PROPERTY & LIABILITY ASSESSMENT AUDIT

VENTURA COUNTY COMMUNITY COLLEGE DISTRICT

RE: SWACC PROPERTY & LIABILITY ASSESSMENT FOLLOW-UP AUDIT

Location: Ventura County Community College Dist. - VENTURA COMMUNITY COLLEGE - Tri-Valley Girls Softball Field (for Lease)

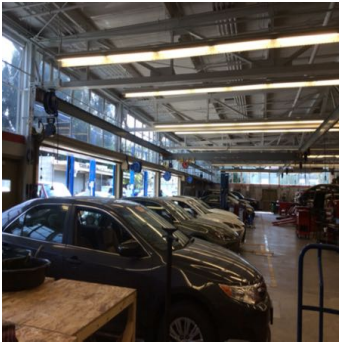
Description: The electrical panel cover is missing and should be replaced. In general, electrical equipment should be secured from public access. To prevent vandalism, consider installing a secure enclosure for the electrical panel.

Action Notes: Martin Navarro is working on this. It is recommended to install an enclosure to prevent any type of vandalism to the electrical equipment.

Location: Ventura County Community College Dist. - VENTURA COMMUNITY COLLEGE - WAM Bldg. Auto Technology Lab

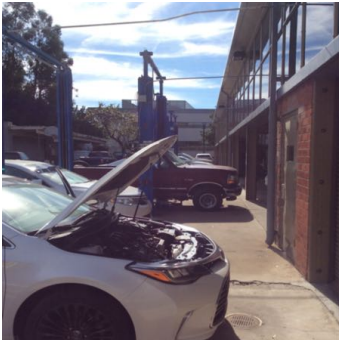
Description: There are no local exhaust ventilation hoses in this shop. The instructors stated that the garage doors are open while vehicles are running; however, local exhaust ventilation should still be provided. Consider installing hoses that can be fully extended to each vehicle workstation. Use of CO monitors is also recommended.

Close Note: This item is in the Department's Program Review for approval. The Automotive Instructors put in the request for ventilation and shelters for their lifts every year. For now, air ducting is being used to vent car exhaust through the garage doors. It is still recommended to install CO monitors for each workstation.
